HISTORIC PRESERVATION BOARD STAFF REPORT

303 SE 7th Avenue

HP-392-2025

Certificate of Appropriateness & Variance

drawing
**PROPOSED
OVERALL
SITE PLAN**
1" = 10'-0"
sheet
AS-2

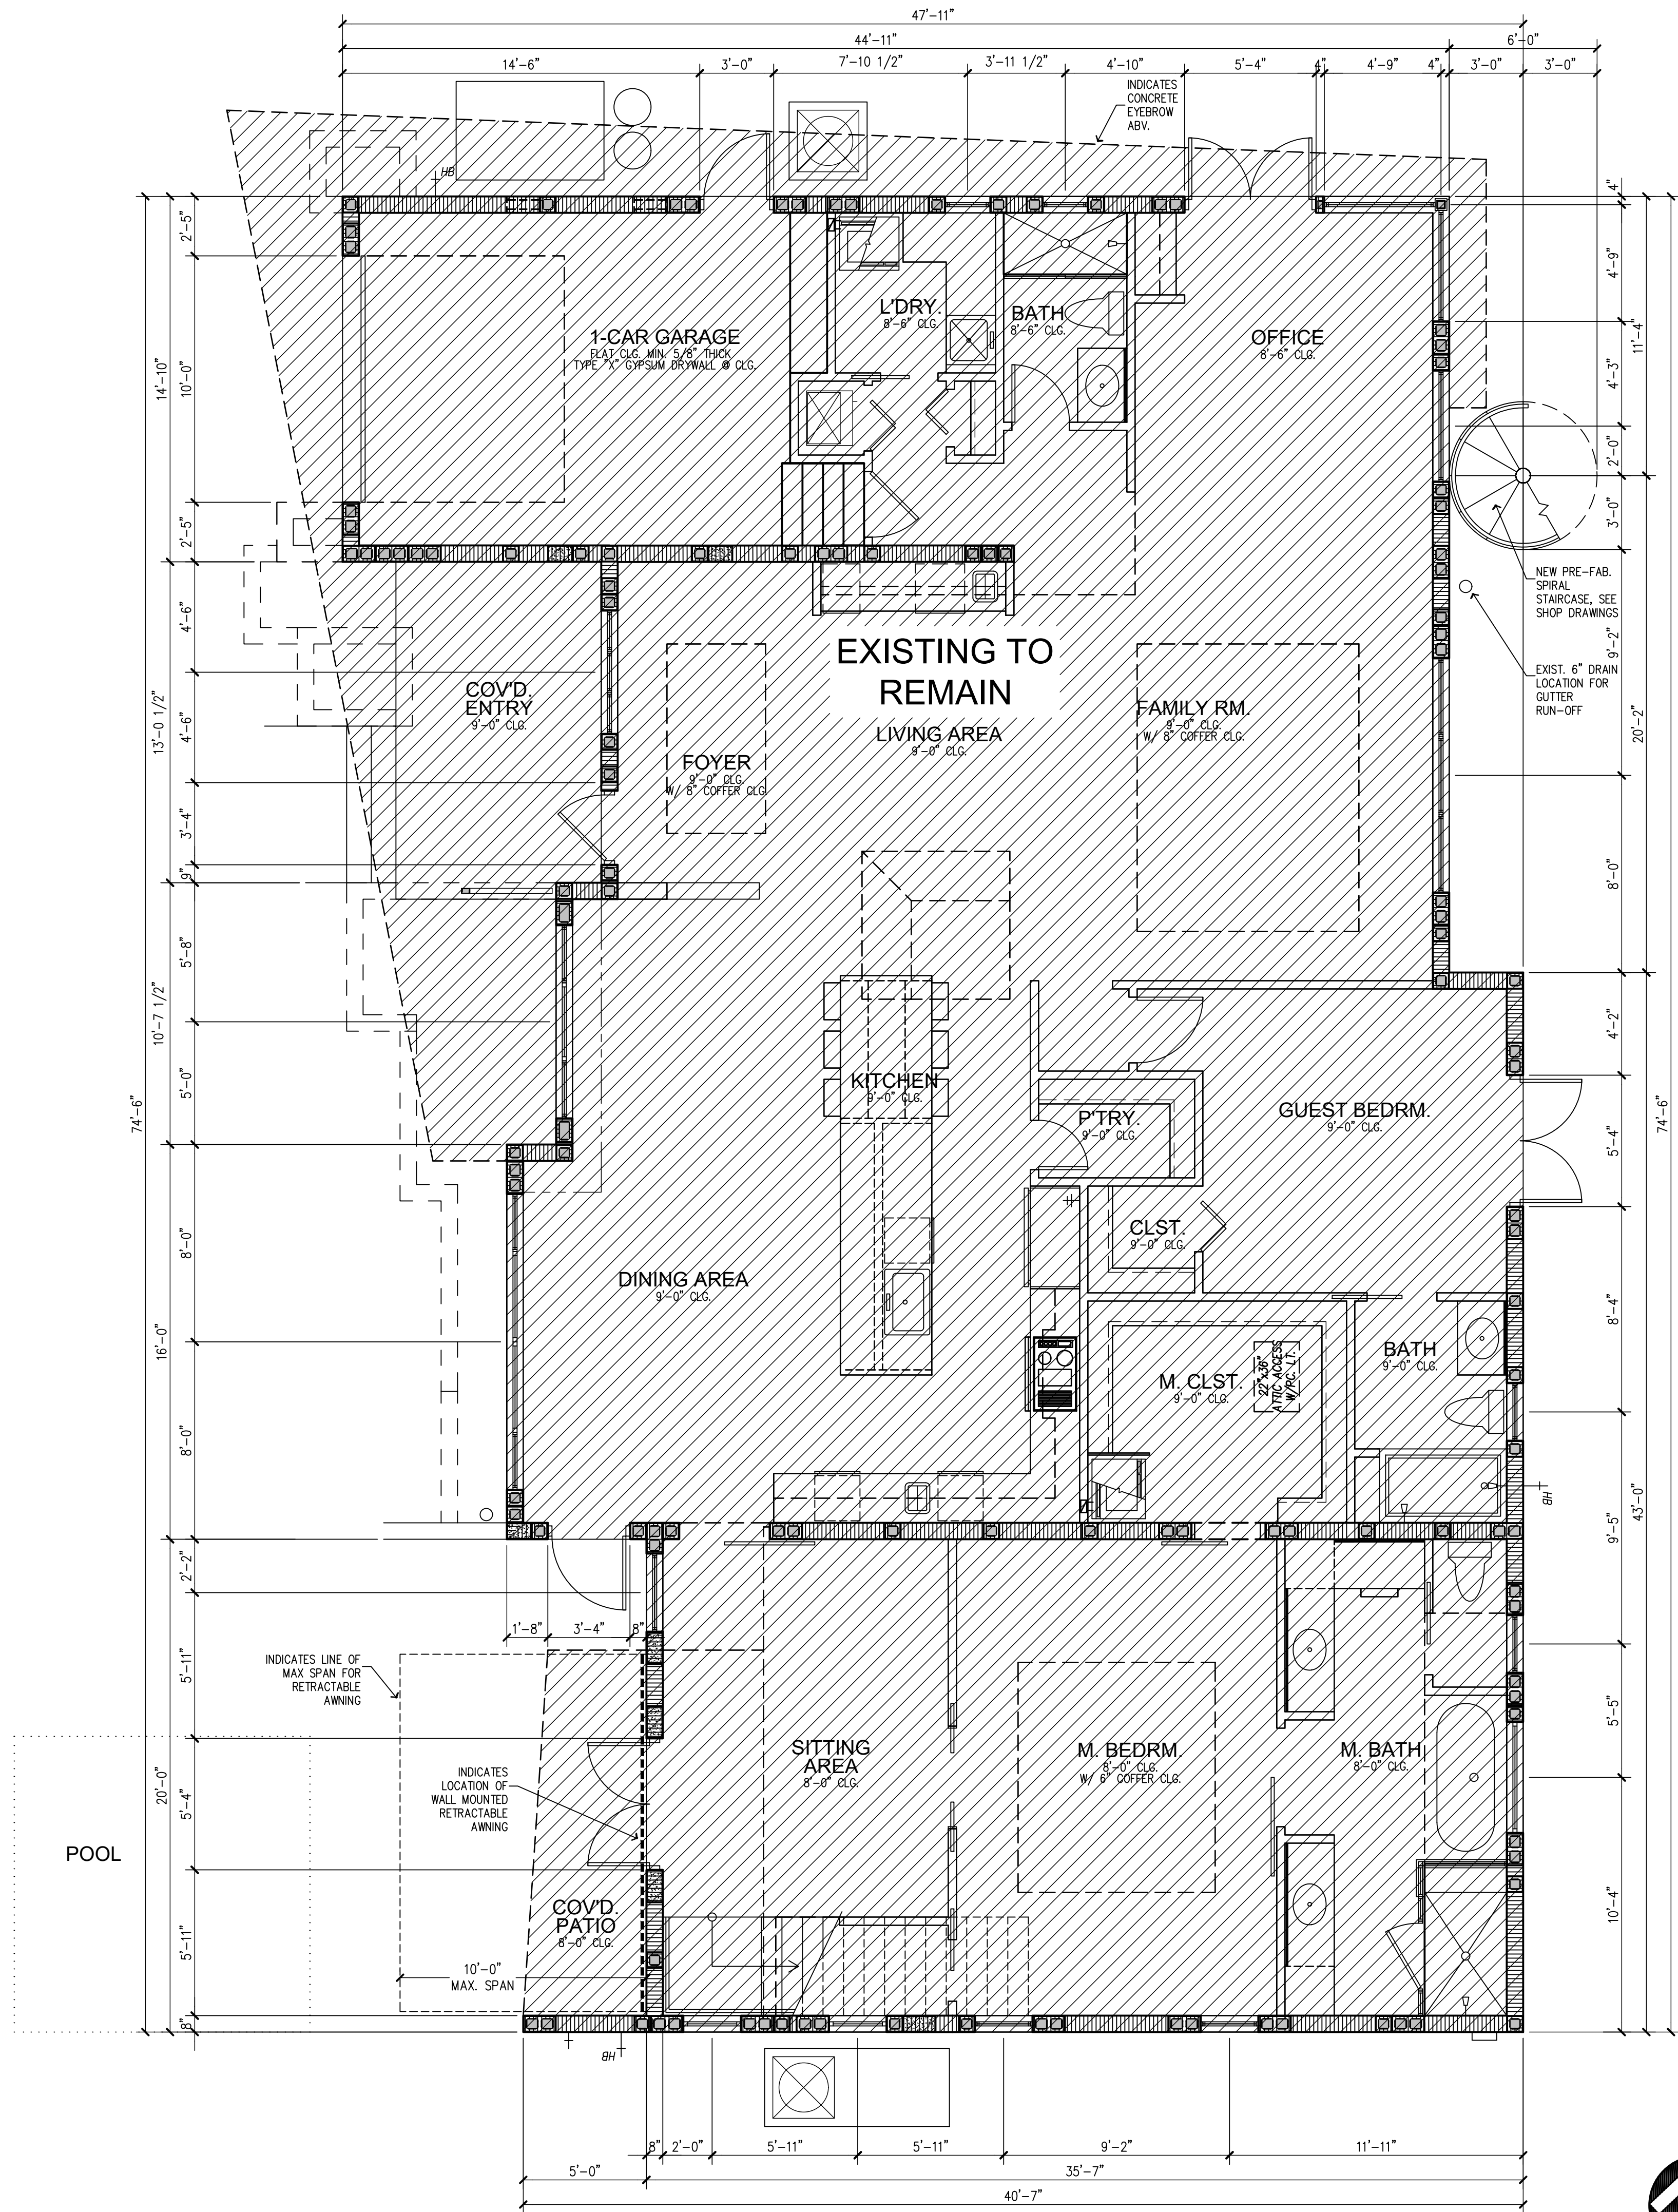
1. Remove all proposed notes that were already approved and are not a part of this request (ex. reconstruction note of the main structure on the proposed site plan).
